(PPSSSH-74) - (2-6 Porter Road, Engadine)

(DA21/0354)

ASSESSMENT REPORT APPENDICES

Table 1: Response to Design Review Forum Recommendations

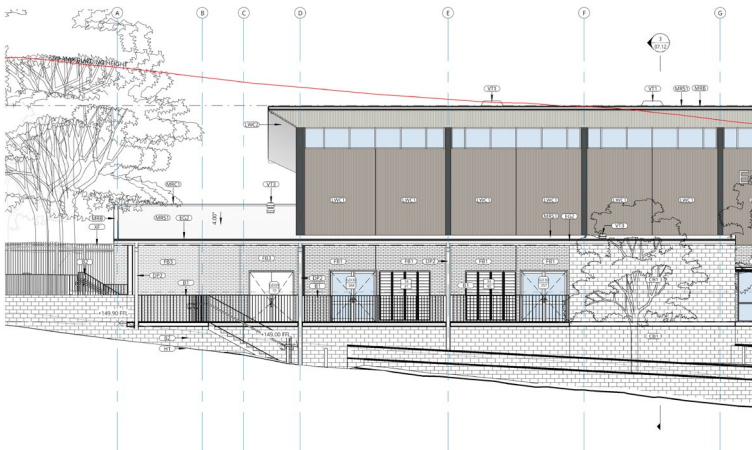
Recommendation	Response
1. Wayfinding and general exterior circulation seem circuitous and awkward. For instance, the first stair adjacent the control room, forces those approaching from the Porter's Road entry to zigzag and double back on their forward path which is unnecessary. A better solution would be to remove this stair and introduce steps between grids A and D, which has a smaller level change compared to the current stair, which in turn will serve access to the outdoor storeroom better, entering directly onto the covered entry forecourt, as well as consolidating with the descending stairs and strengthen the sense of arrival and improve wayfinding.	<p>The first stair located adjacent to the control room has been relocated and re-orientated as shown on the updated ground floor plan and east elevation (Figure 1).</p>  <p><i>Figure 1 Extract of East Elevation of multi-purpose hall showing new location of stairs and extension to planters</i></p>

2. The above change will also allow the front low planters to extend another 13.5m or so, creating a more aesthetic and linear approach to the new stairs/forecourt and which would further improve the green base upon which the building is sitting, as well as further reduce the sense of bulk and the issue of height non-compliance at the part of the building.	<p>The relocation of the stairs has resulted in the extension to the low height planters along the eastern elevation of the building (Figure 1).</p>

3. The submission generally has inadequate documentation to allow the Panel to assess quality and impacts as it does not show the context adequately and fails to inform via key contextual data such as clear site analysis drawings, showing fine grain context, street and neighbourhood context etc.	<p>As noted in Section 1.2 of this letter, an additional site analysis plan has been prepared by Project Architect, Webber Architects that provides a streetscape and street setback analysis of surrounding development on Porter Road and Birok Avenue.</p>

4. As a part-time public community building, it disappoints in this role by its lack of ease of entry access, which could be improved with the above comments.	<p>The principle use of the building is as an educational facility for the use of students. However, the building has been designed to have a strong street presence to Porter Road and may have some community use, at the discretion of the school when not been utilised by the school. It is also noted that the stair access has been rotated 180 degrees to provide improved and more direct access from Porter Road.</p>

Figure 3 Porter Road elevation of the proposed multi-purpose hall

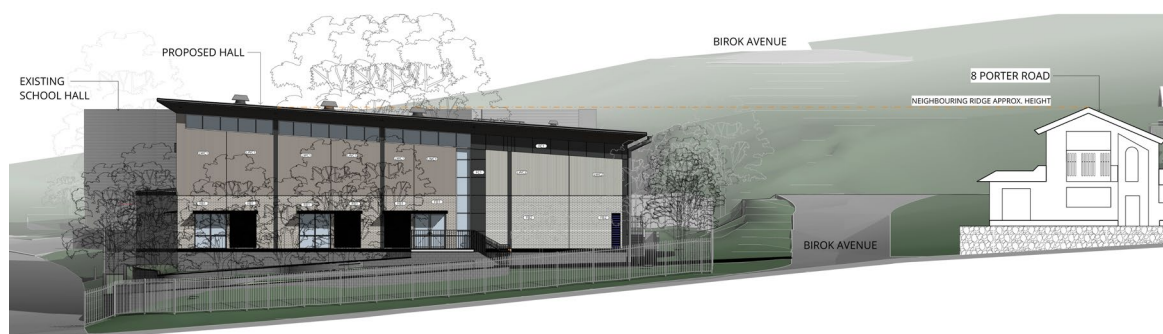
A streetscape and setback analysis has been undertaken by Webber Architects showing the setbacks along Porter Road and Birok Avenue (Drawing Number SK-14). Existing front setbacks along Porter Road range from a minimum of 5.2m to a maximum of 9.9m. Existing front setbacks along Birok Avenue range from 3.3m to 16.2m. The proposed multi-purpose hall has a setback of 9.2m to Porter Road and of 5.8m to Birok Avenue, which is consistent with the prevailing setbacks on Porter Road.

The proposed multi-purpose hall has been deliberately sited to provide a street presence and address for the school (**Figure 3**).

Figure 2 North Elevation of Proposed Multi-purpose Hall

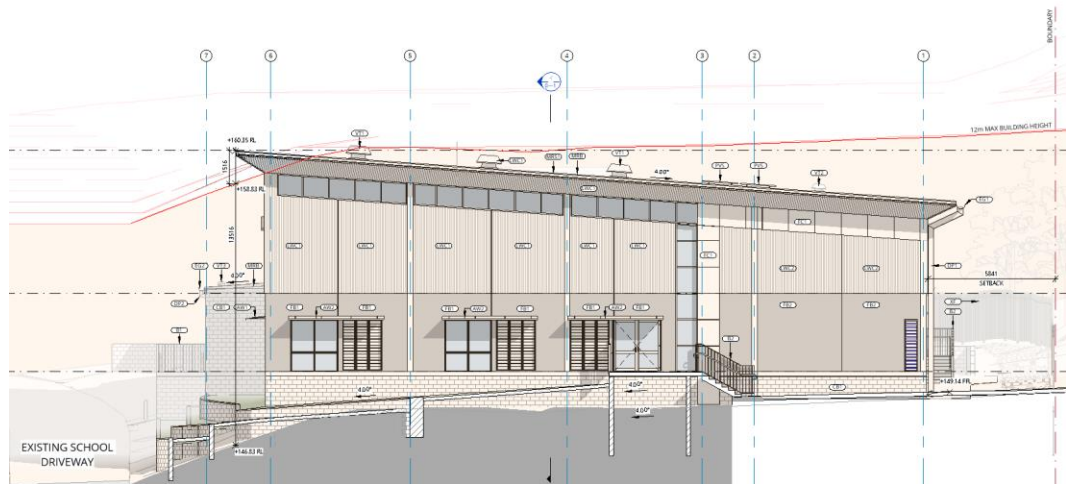
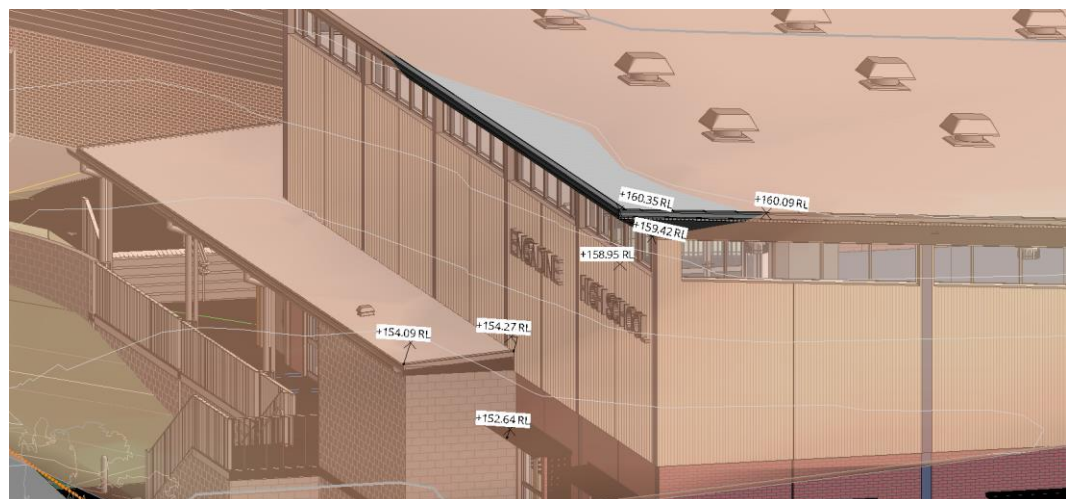
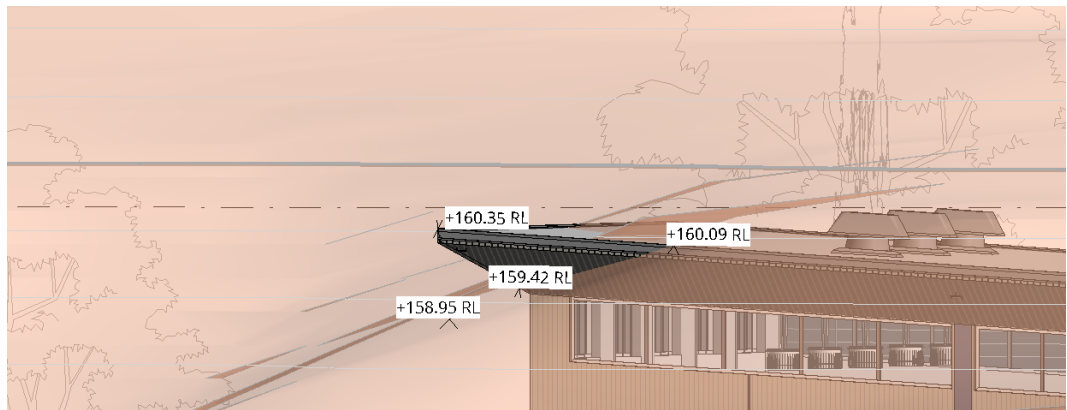
The proposed development requires a variation to the height of buildings development standard under clause 4.3 of the Sutherland Shire LEP 2015. The multi-purpose hall has a maximum height of 13.56 metres. The roof exceeds the height limit on the northern end of the hall by 1.56 metres, which is the equivalent to a variation of 13%. The non-compliance is the result of the sloping terrain towards the internal driveway and Porter Road. The non-compliance is considered minor.

The extent of the non-compliance is shown in extracts of the elevations at **Figure 2 to 5**.

Figure 3 Building Height Plane – showing full extent of height variation limited to north-eastern roof peak

Figure 4 Building Height Plane – close perspective on full extent of height variation

Figure 5 Building Height Plan – detailed view of extent of variation
